Subject: Notification of Class 1 Permit Modification to the Waste Isolation Pilot Plant  
Hazardous Waste Facility Permit Number: NM4890139088-TSDF

**Class 1 Permit Modification Notifications**

**Waste Isolation Pilot Plant**

**WIPP Permit Number - NM4890139088-TSDF**

**Figure A4-4**  
**Typical Underground Transport Route Using E-140**

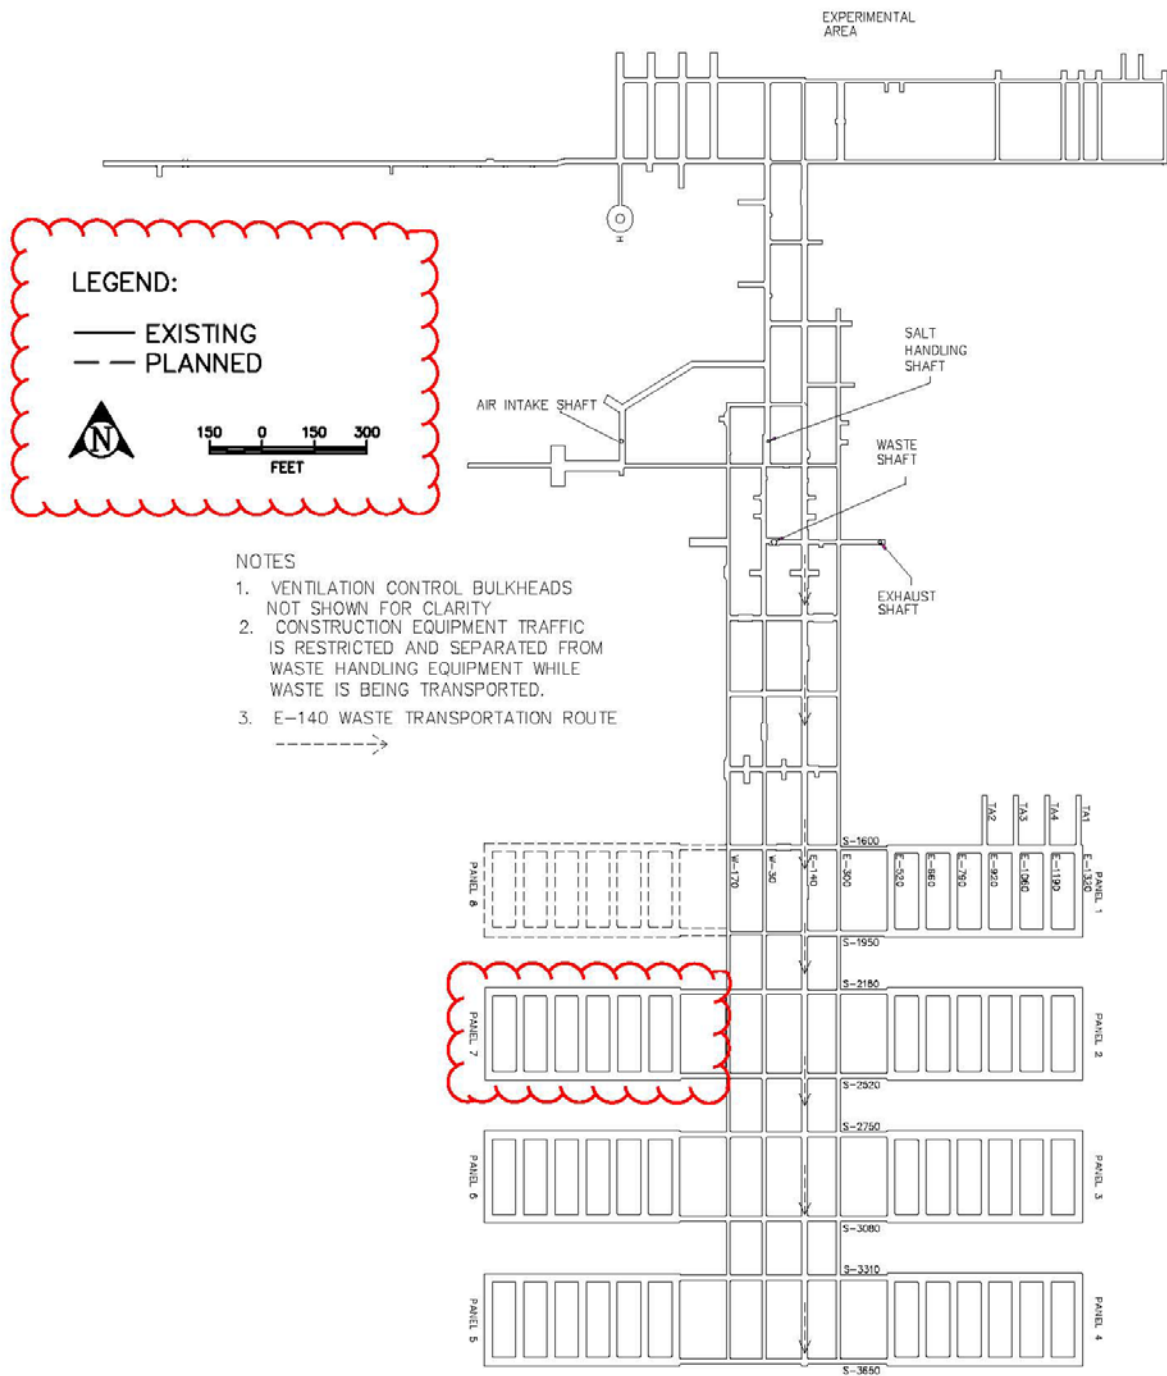
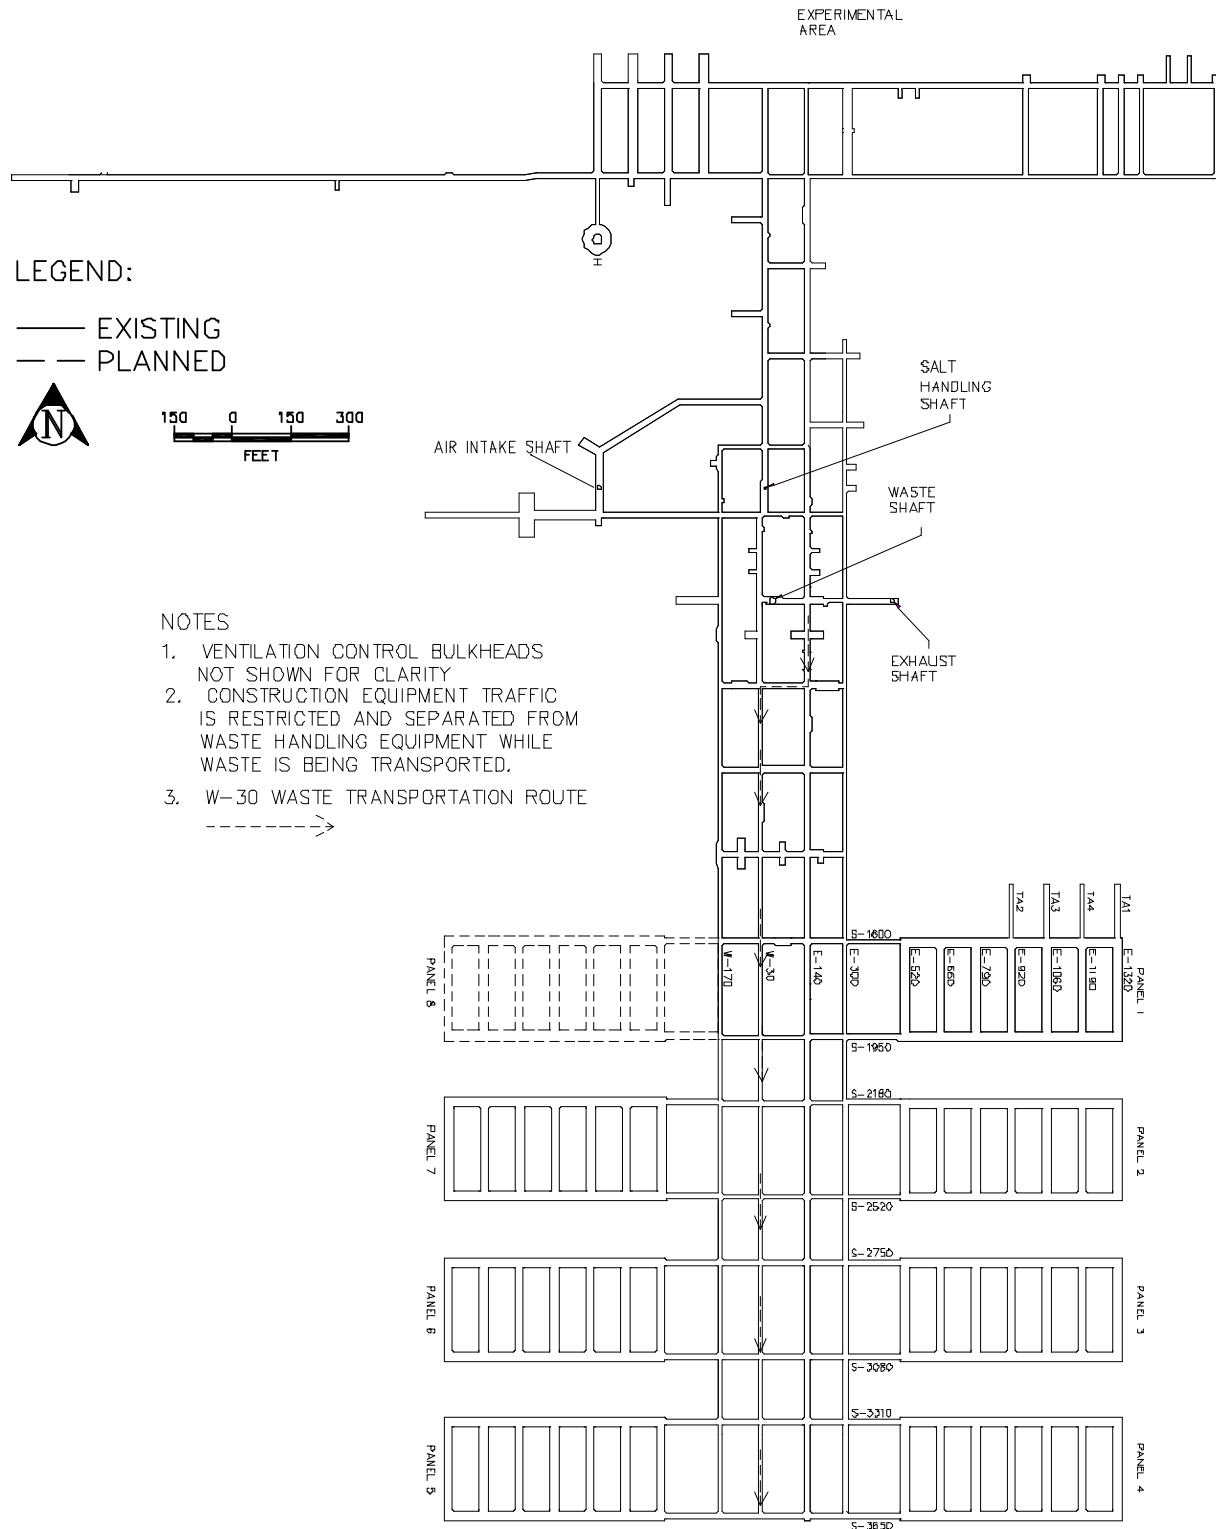
This modification revises Permit Attachment K, Table K-4 and Permit figures A2-1, A4-4, A4-4a, B3-2, D-3, D-5, D-9, G-1, G-6, G2-1, and N-1 to indicate that Panel 7 has been approved by the NMED. The text “SWMU 013i Underground HWDU – Panel 7” is being added to Attachment K, Table K-4. The figures were updated by changing Panel 7 status from “planned” to “existing” hazardous waste disposal unit (HWDU). This is done by changing dashed lines to solid lines or by adding Panel 7 to respective figures. Additional editorial changes were made to some figures which included the following: added legend, north arrow, and scale to Figures A4-4 and A4-4a; added Panel legend (for existing and planned Panels) and moved north arrow and scale to top of Figure D-5; added borehole markers for boreholes H-16 and WIPP-19 and moved H-16 borehole caption to the right on Figure G-6. Also see the Table of Changes and the “clouded” figures in Appendix C of this PMN for a description of these changes.

On July 16, 2013, the Permittees were notified by the NMED that Panel 7 had been constructed in compliance with the requirements of the Permit. Panel 7 is now available for waste emplacement. Figures A2-1, A4-4, A4-4a, B3-2, D-3, D-5, D-9, G-1, G-6, G2-1 and N-1 have been revised to show that Panel 7 is now authorized for waste disposal. The change removes the “dashed” lines and replaces them with “solid” lines in order to change the designation from “planned” HWDU to “existing” HWDU.

**Figure B3-2**  
**Repository Horizon**

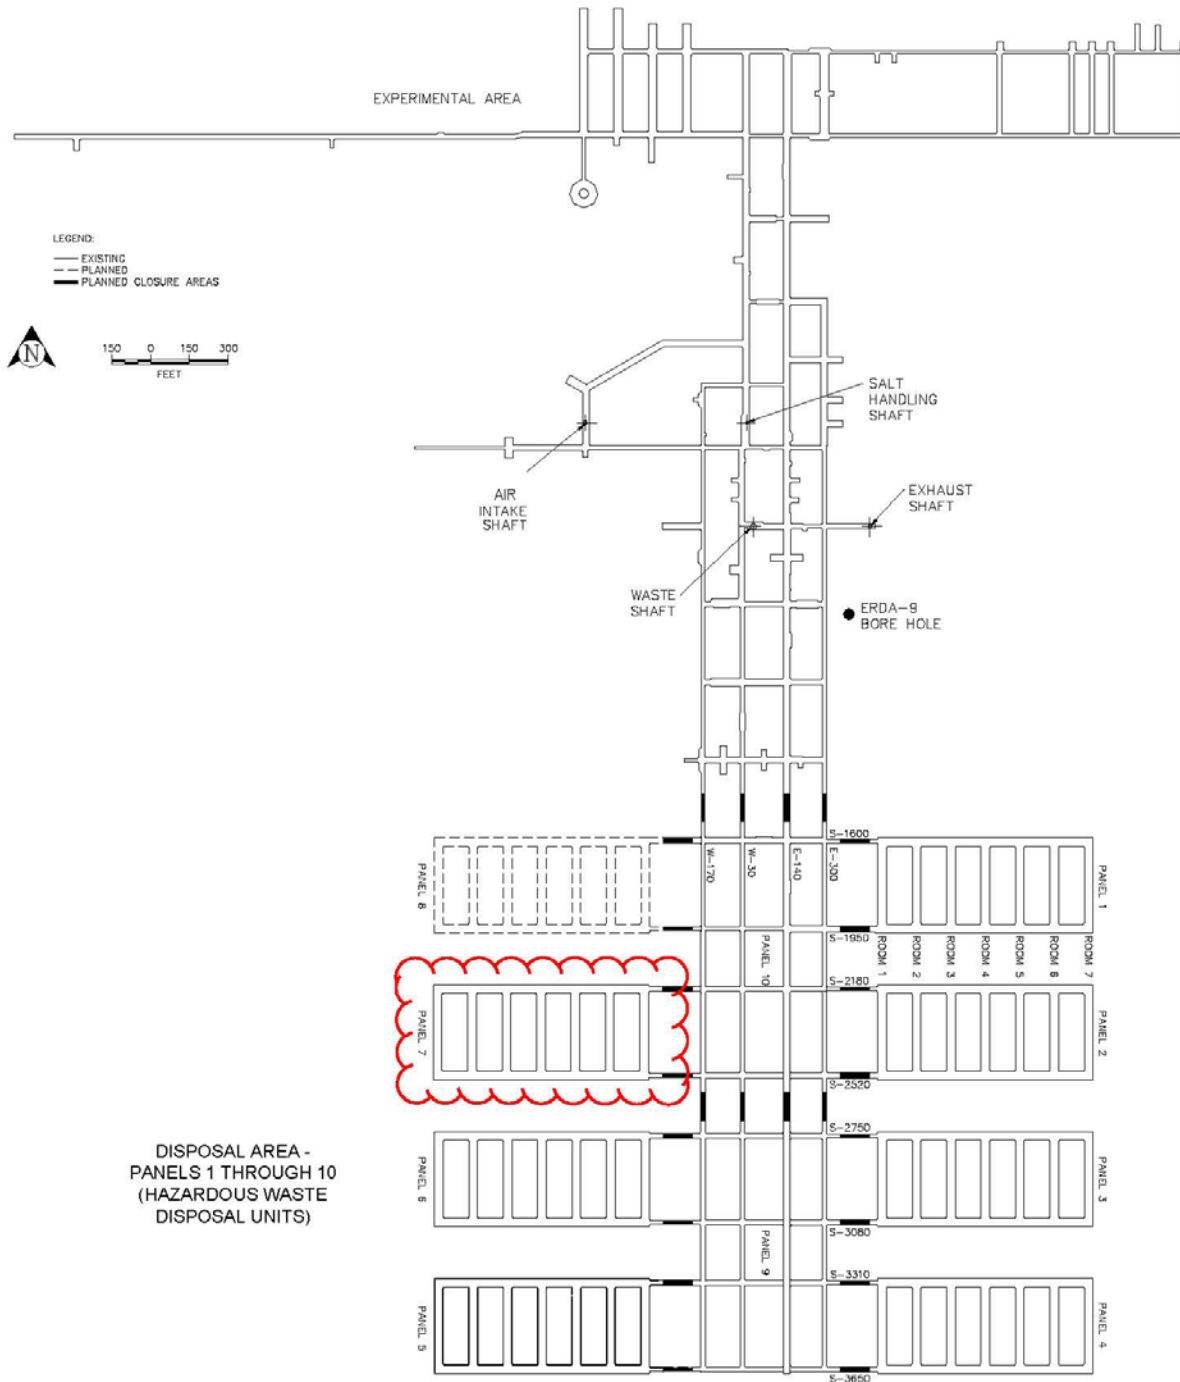
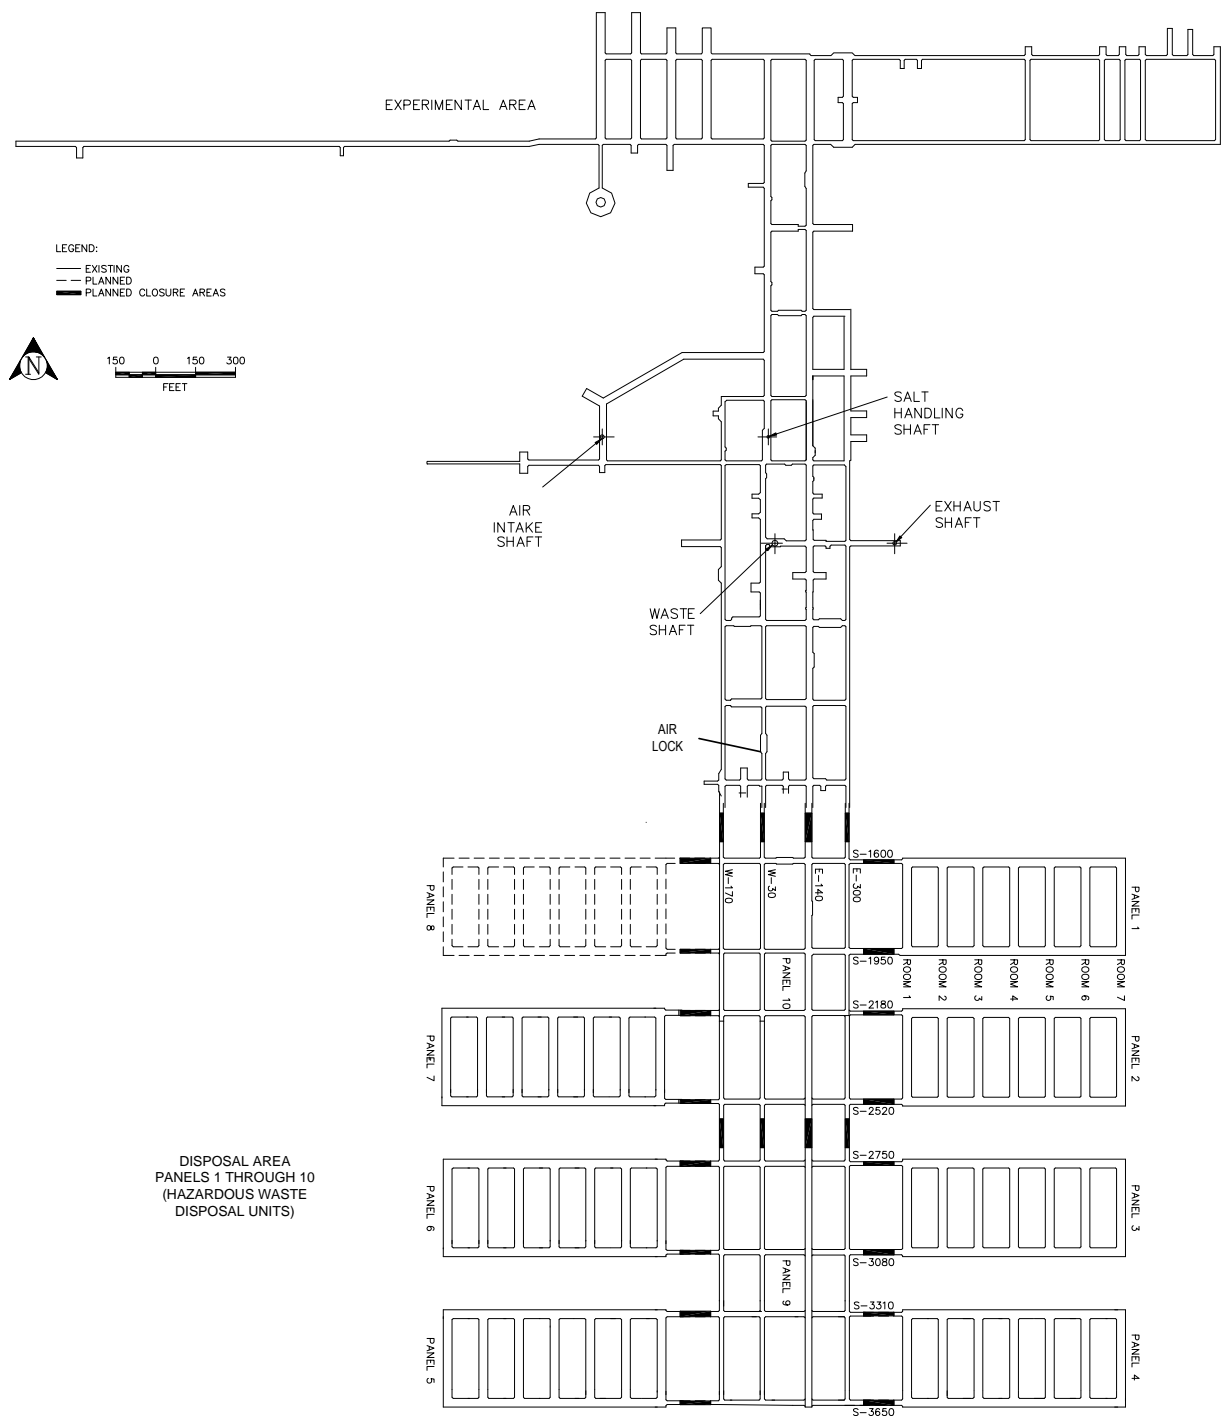
<b>Item No</b>	<b>Affected Permit Section</b>	<b>Change Description</b>	<b>Category</b>
1	Attachment F2	Revise the course outline, <i>Radiological Control Technician Site-Specific Academic Lessons</i> , in Permit Attachment F2 to allow Radiological Control Technicians (RCTs) students to test out of all or part of the courses listed in this outline.	B.5.b
2	Attachment K, Table K-4	Revised table to indicate that Panel 7 has been approved for use.	A.1
	Attachment A2, Figure A2-1	Revised figure to indicate that Panel 7 has been approved for use.	A.1
	Attachment A4, Figure A4-4	Revised figure to indicate that Panel 7 has been approved for use. Added legend, north arrow, and scale.	A.1
	Attachment A4, Figure A4-4a	Revised figure to indicate that Panel 7 has been approved for use. Added legend, north arrow, and scale.	A.1
	Attachment B3, Figure B3-2	Revised figure to indicate that Panel 7 has been approved for use.	A.1

**Figure D-3**  
**WIPP Underground Facilities**

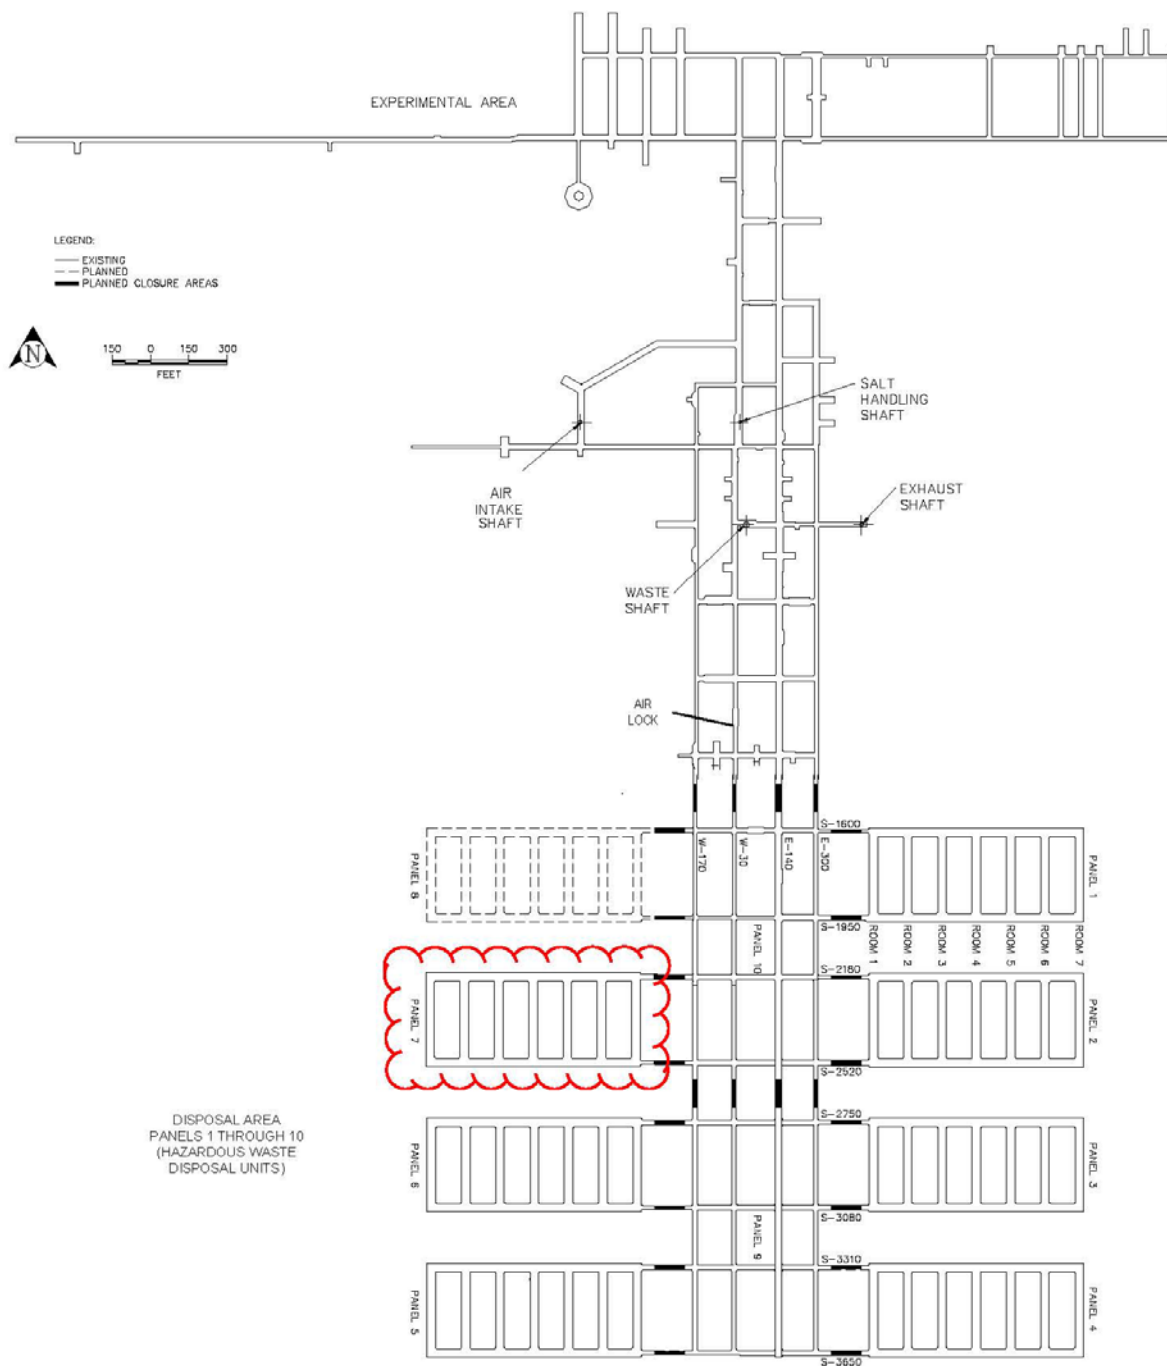
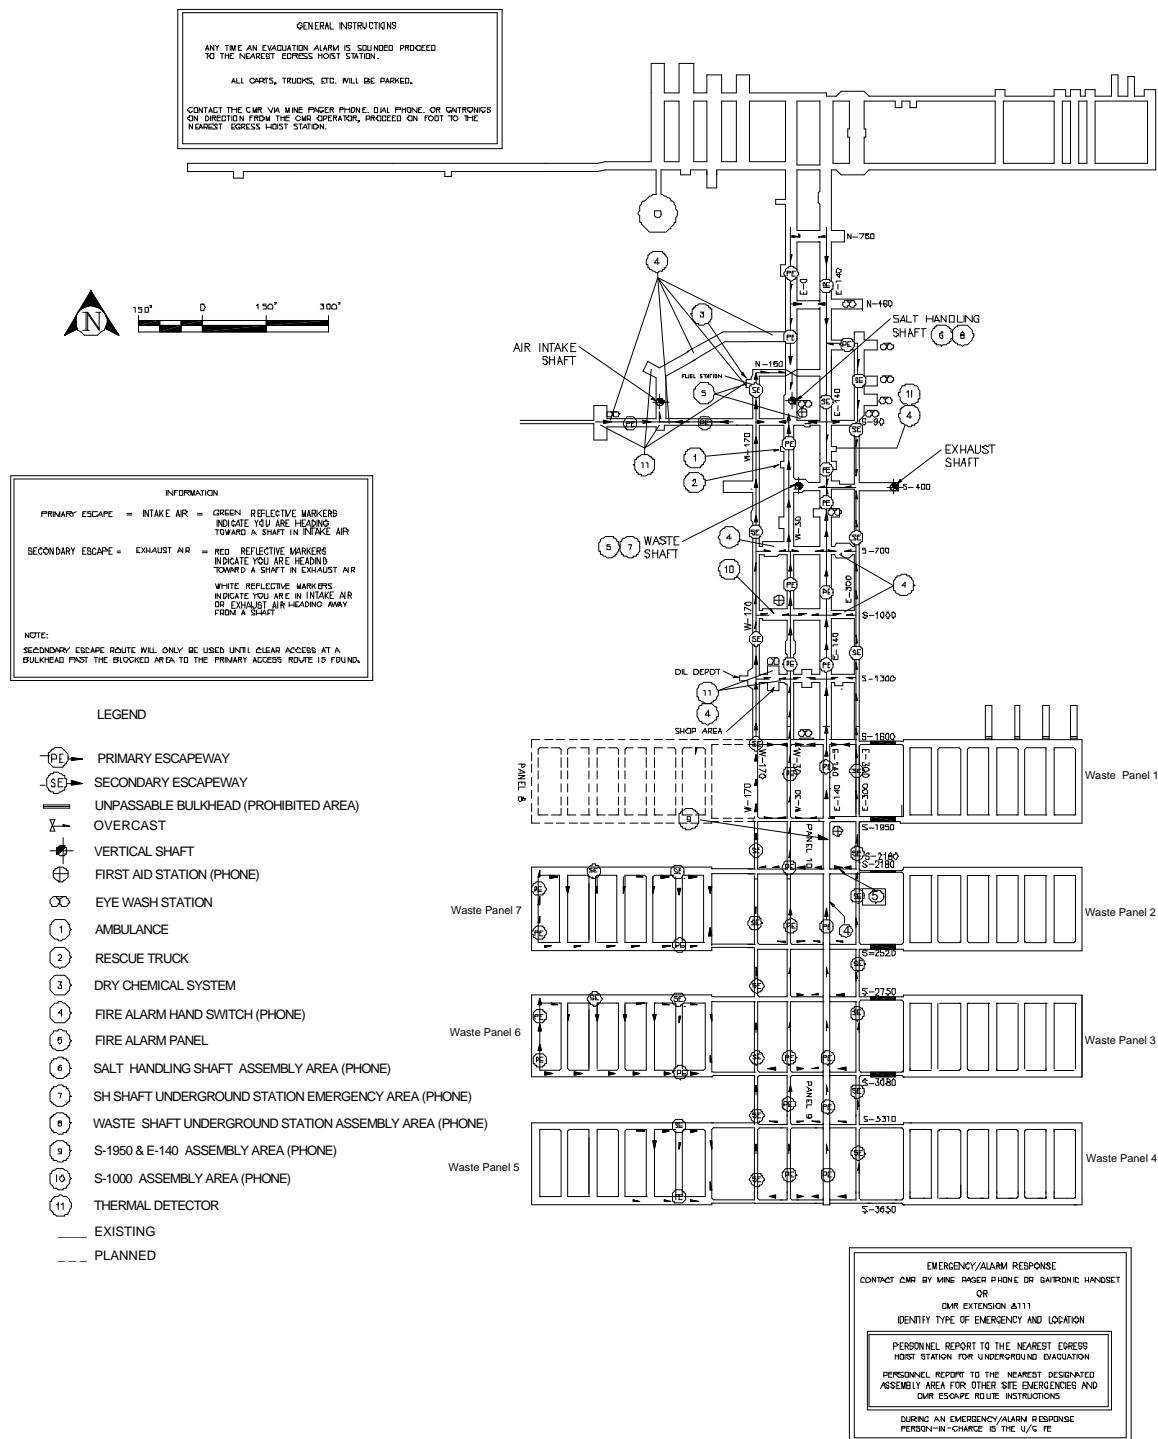
Attachment D, Figure D-3	Revised figure to indicate that Panel 7 has been approved for use.	A.1
	Attachment D, Figure D-5	Revised figure to indicate that Panel 7 has been approved for use. Added legend. Moved north arrow and scale to the top of the figure.	A.1
	Attachment D, Figure D-9	Revised figure to indicate that Panel 7 has been approved for use.	A.1
	Attachment G, Figure G-1	Revised figure to indicate that Panel 7 has been approved for use.	A.1
	Attachment G, Figure G-6	Revised figure to indicate that Panel 7 has been approved for use. Added marks for the H-16 and WIPP-19 boreholes. Moved the H-16 caption to the right.	A.1
	Attachment G2, Figure G2-1	Revised figure to indicate that Panel 7 has been approved for use.	A.1
	Attachment N, Figure N-1	Revised figure to indicate that Panel 7 has been approved for use. Added “existing” and “planned” to the legend. Added a scale and moved the north arrow. Added Panel 8 to the figure as “planned.”	A.1
